ADDRESS : 109 GRAHAMRIDGE LN
 CONTRACTOR : SHRIEVES MICHAEL
 OWNER : ANDREWS DONALD R & MARGIE N #3
 PARCEL : 04-0664- - -0038- -34-
 APPL NUMBER: 07-50017464 CP NEW RESIDENTIAL (SFD)
 DIRECTIONS : WYNDHAM PLACE #3 PHII - 401N TO
 LAFAYETTE RD RT GO CHALYBEATE SRINGS RD
 RT TO WELLS RD LEFT T RAWLS CH RD RT
 APPROX .5MILES S/D ON RT TAKE 1ST PAVED
 RT ON LEFT LOT ON LEFT OF CULDESAC. JD

RE: **Structural Analysis, Revised**
Triangle Residential Designs, TRD Stock Plan TRD-2-2249
John Wilson, 3008 Rawls Church Road, Fuquay-Varina, NC, 27526
Residence Plan

Lot #3, Wyndham Place Sub'd.
Hamett County, North Carolina
Hamett County Permit No. _____

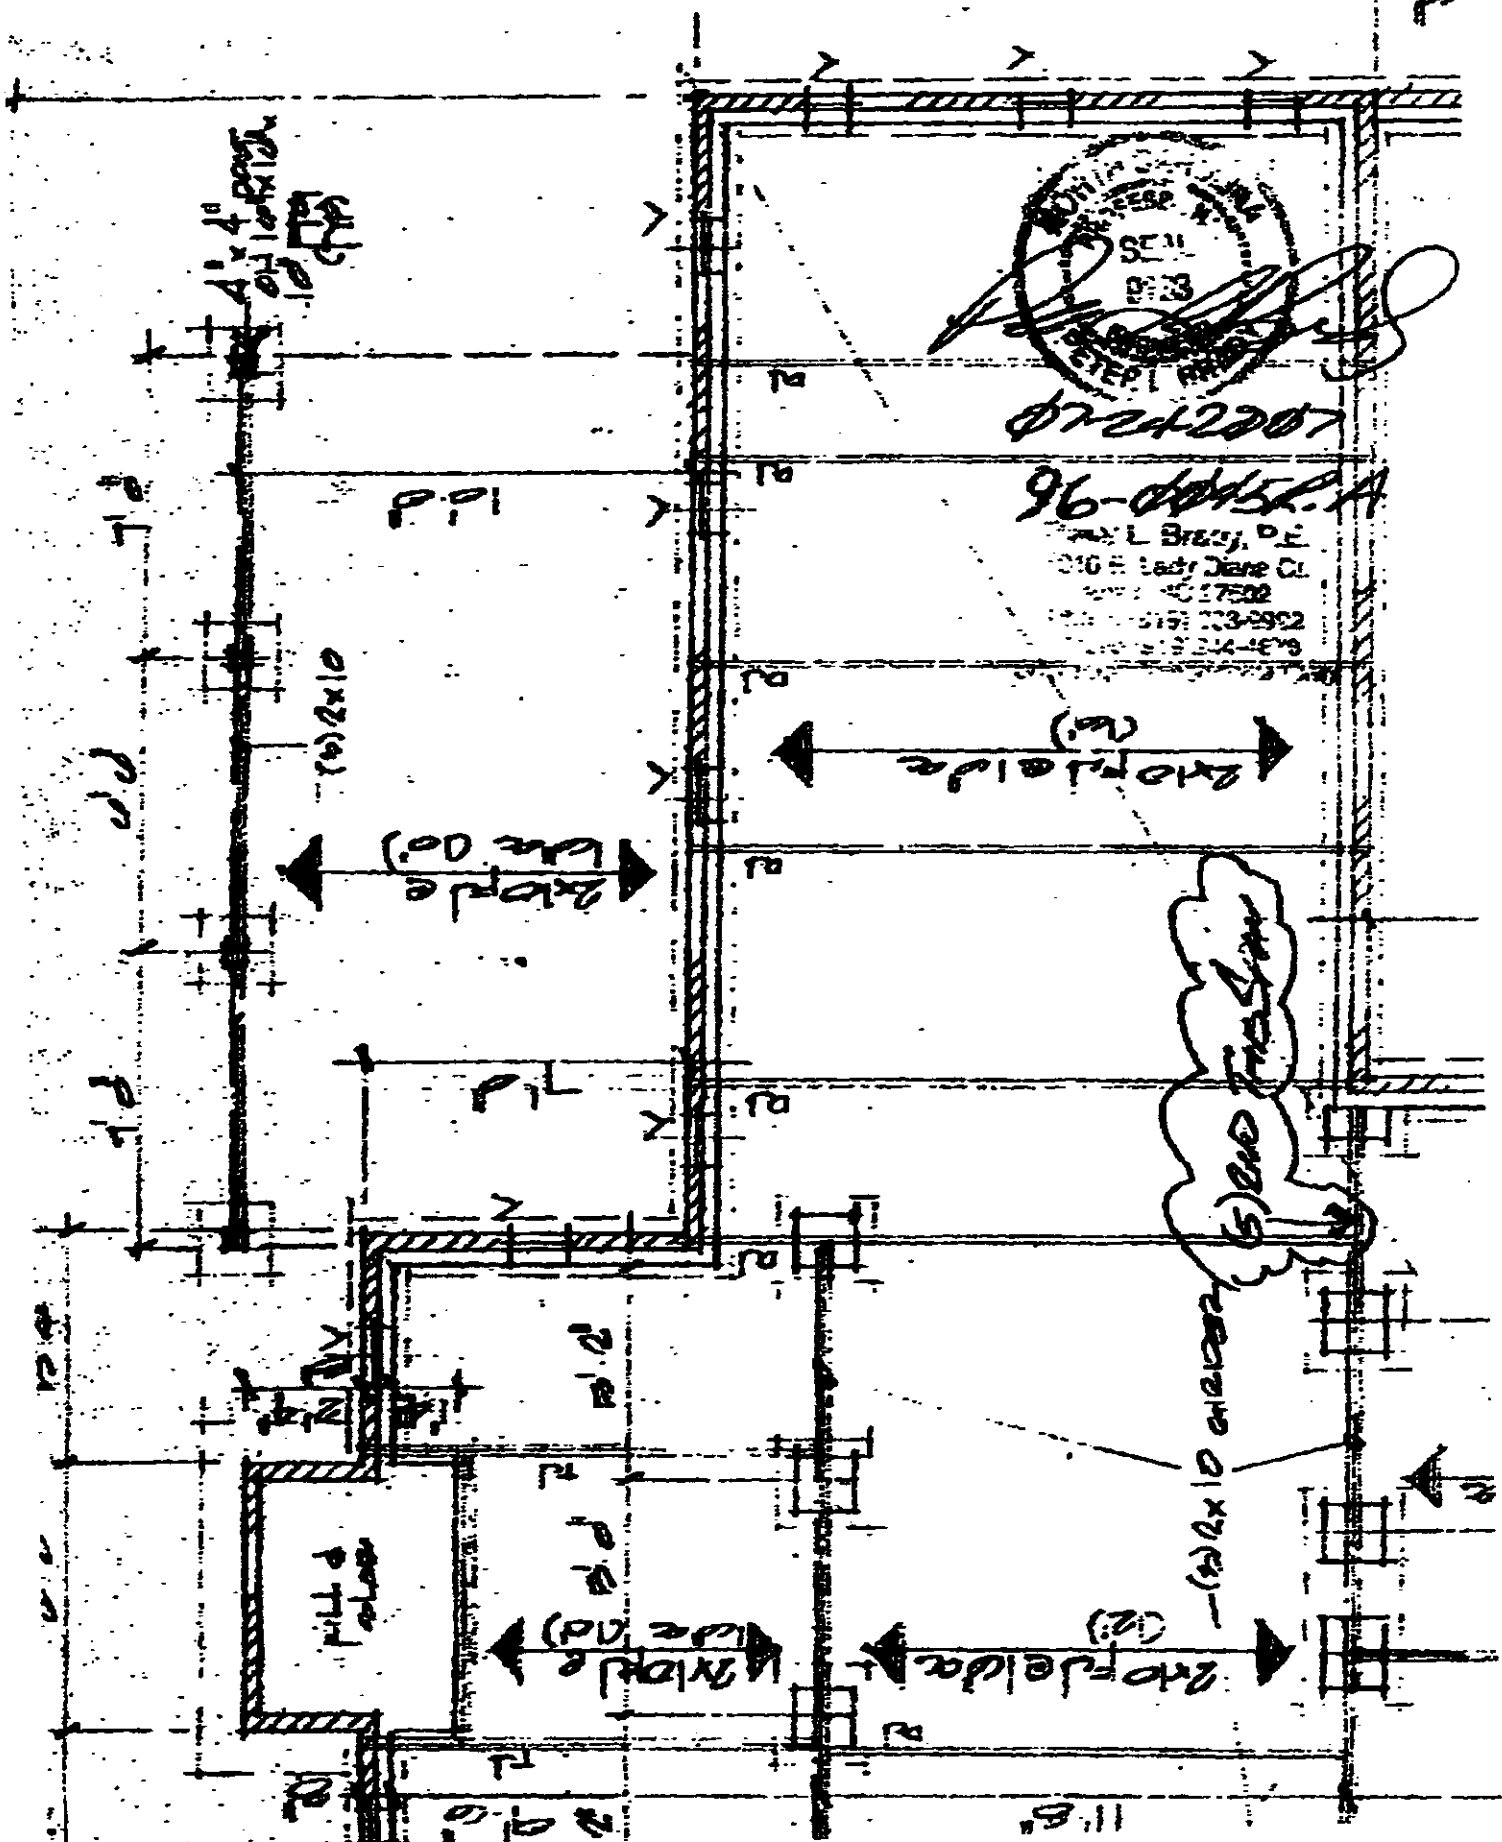
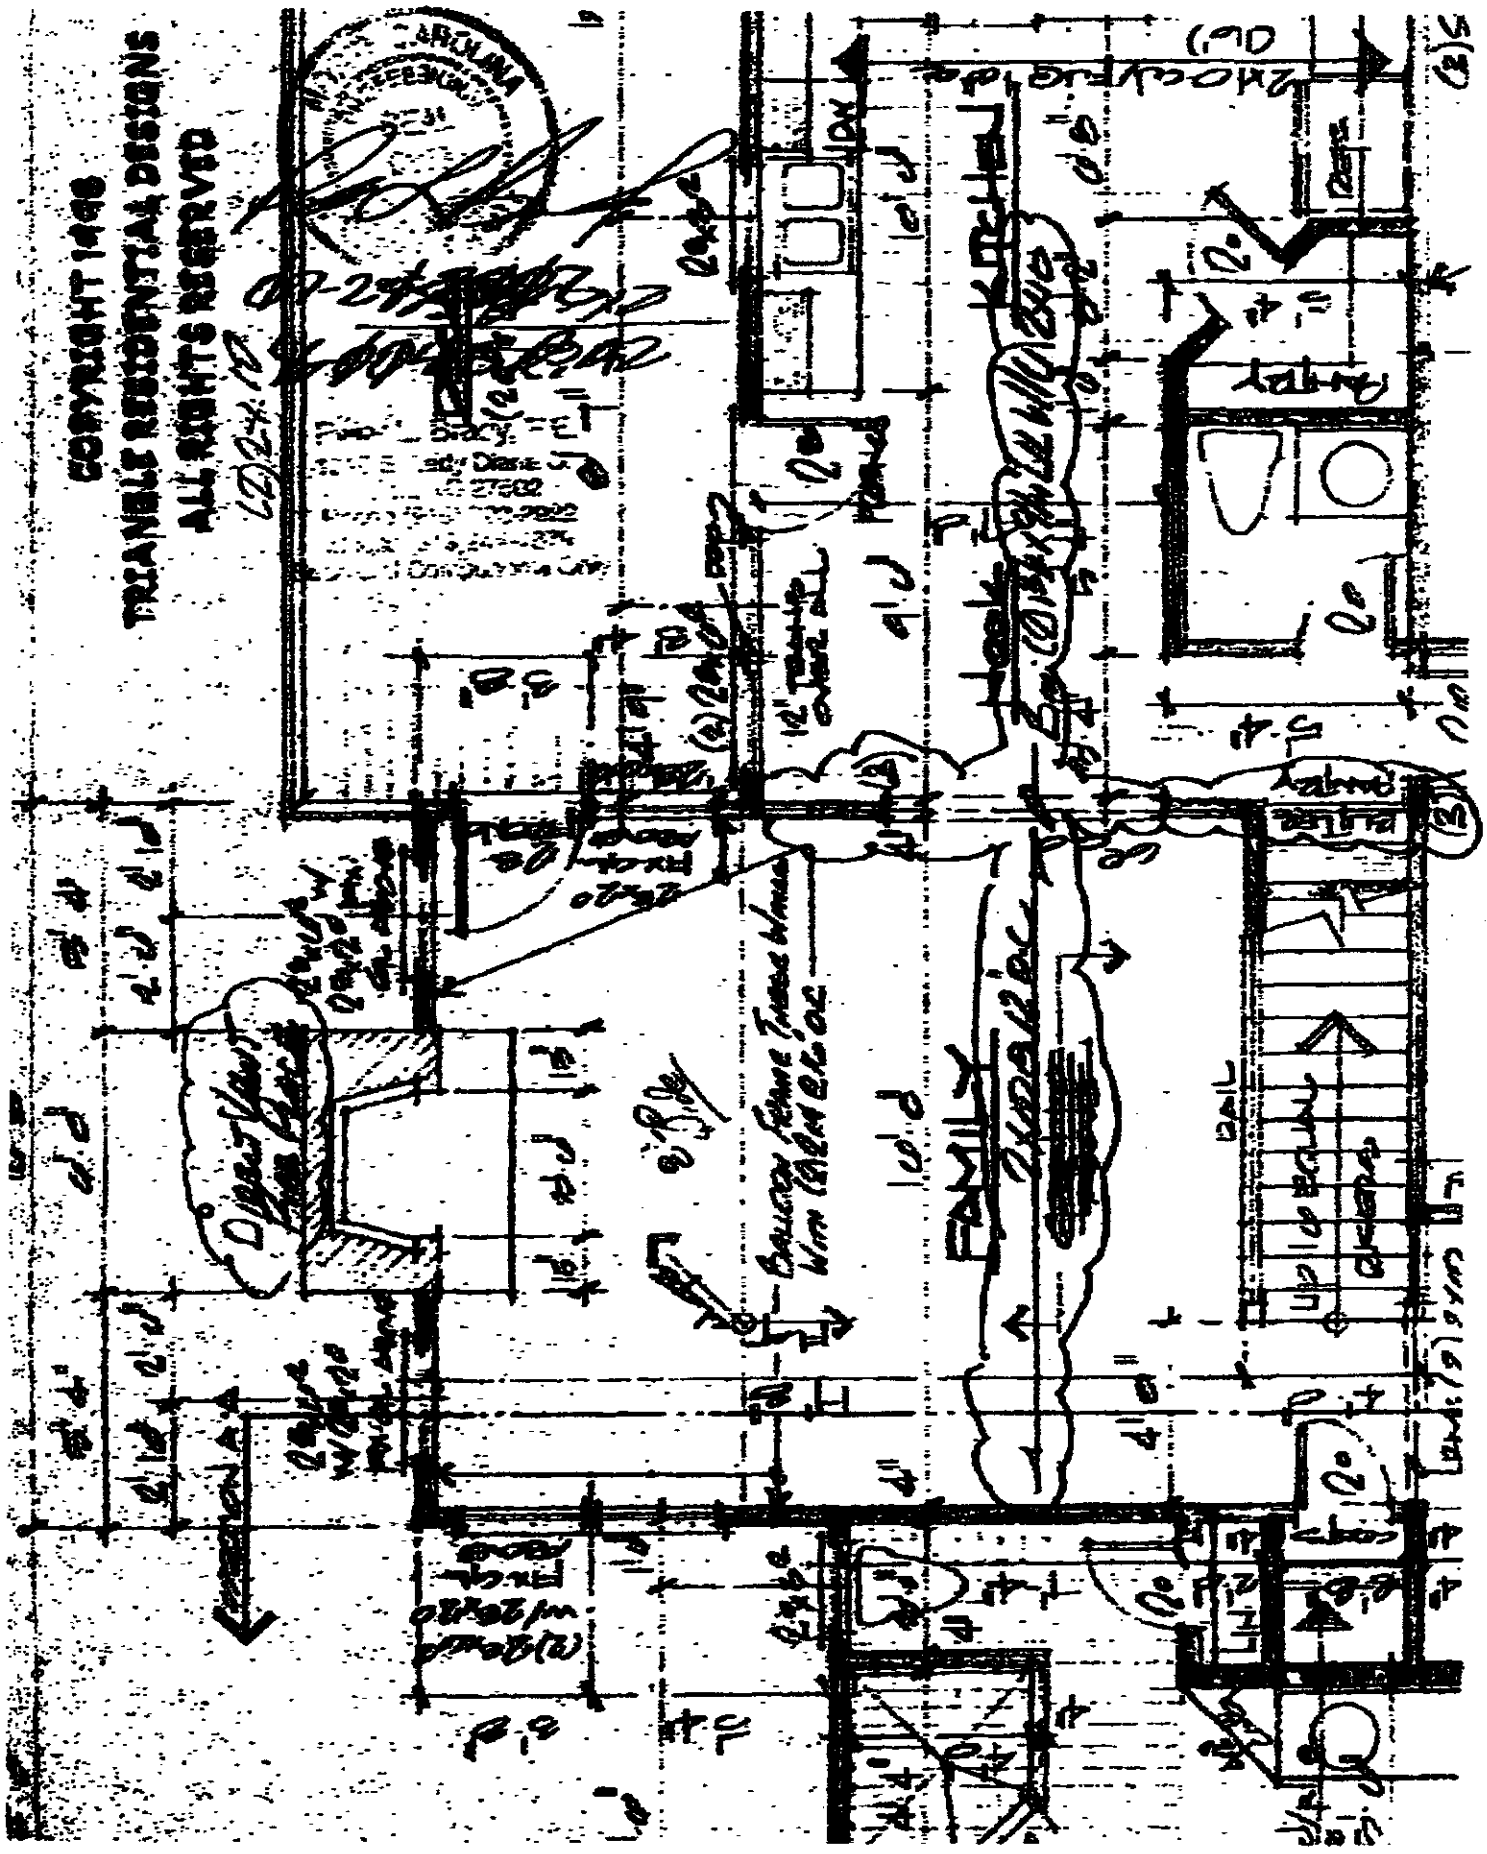
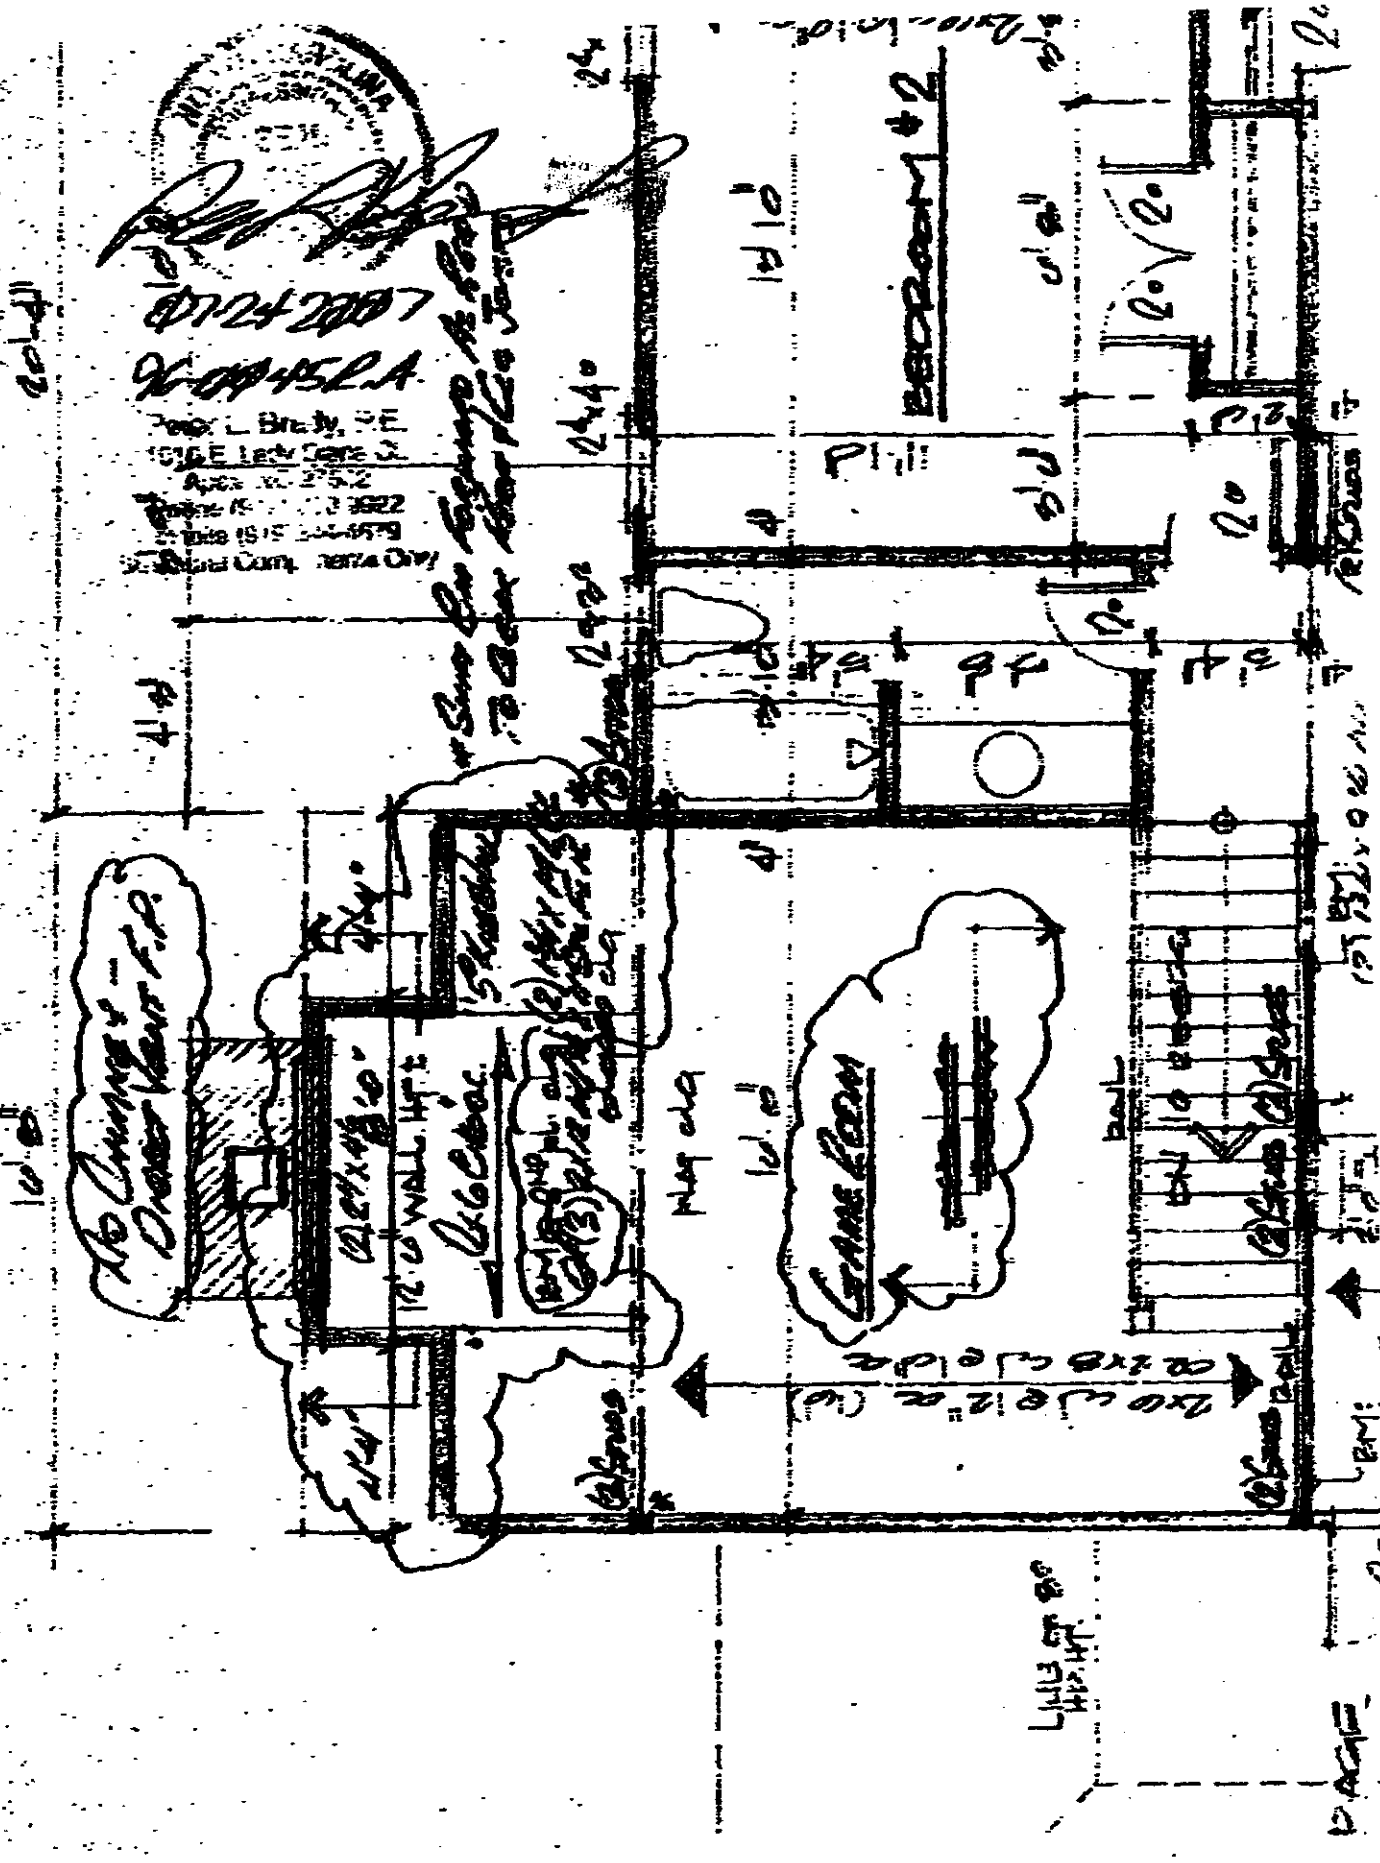
At your request, I have reviewed the structural requirements for placing a floor over the family room. The developable areas of this floor area will be a game room and has been designed for a 40 psf live load. In addition the roof will be modified to include an eight foot wide gable roofed dormer.

The attached partial plans provide the details for this structural modification. The following modifications are required:

- 1) The game room dormer sidewall carrier rafters are acceptable as 2-2"x8", #2SPF, minimum rafters.
- 2) The side-to-side second floor ceiling/roof carrier beam remains appropriate as 2-1 3/4"x14" Laminated Veneer Lumber, LVLs. (minimum design strength is E = 1.9x10⁶ psi; F_b = 2600 psi and; F_v = 285 psi. However, the 2-2"x12", #2SPF or #2SYP, with a 1/2"x11" steel fitch plate option will require 3-2"x12"s with the revised roof loading.
- 3) The side-to-side game room dormer ceiling joists shall be 2"x4", #2SPF, minimum placed at sixteen inch centers.
- 4) The side-to-side game room rafters are appropriate as 2"x6", #2SPF, minimum placed at sixteen inch centers. The dormer ridge shall be a 2"x8", #2SPF, minimum. The game room dormer roof valley may be constructed by over-

framing on the main roof rafters, supporting the dormer rafters on a 2"X sleeper placed on the main roof.

- 5) The side-to-side game room floor joists are acceptable as 2"X10", #2SPF, placed at sixteen inch centers.
- 6) Place a 2-1 3/4"X9 1/4" LVL with 1-2"X10" beam at the family room/nook common wall extending from the dining room stair/common wall to the rear nook wall. Provide three stud bearing support at the dining room/stair common wall, the rear side of the opening between the family room and nook (which bears over an underlying girder and pier) and the rear nook wall.
- 7) The side-to-side rear dining room/stair common wall girder span adjacent to the garage shall be installed as a 5-2"X10" member to support the point load from the front end of the beam described in item six, above.
- 8) Since a second floor-floor will be placed over the family room, the rear side and exterior walls of the family room do not need to be balloon framed as indicated on the plans.
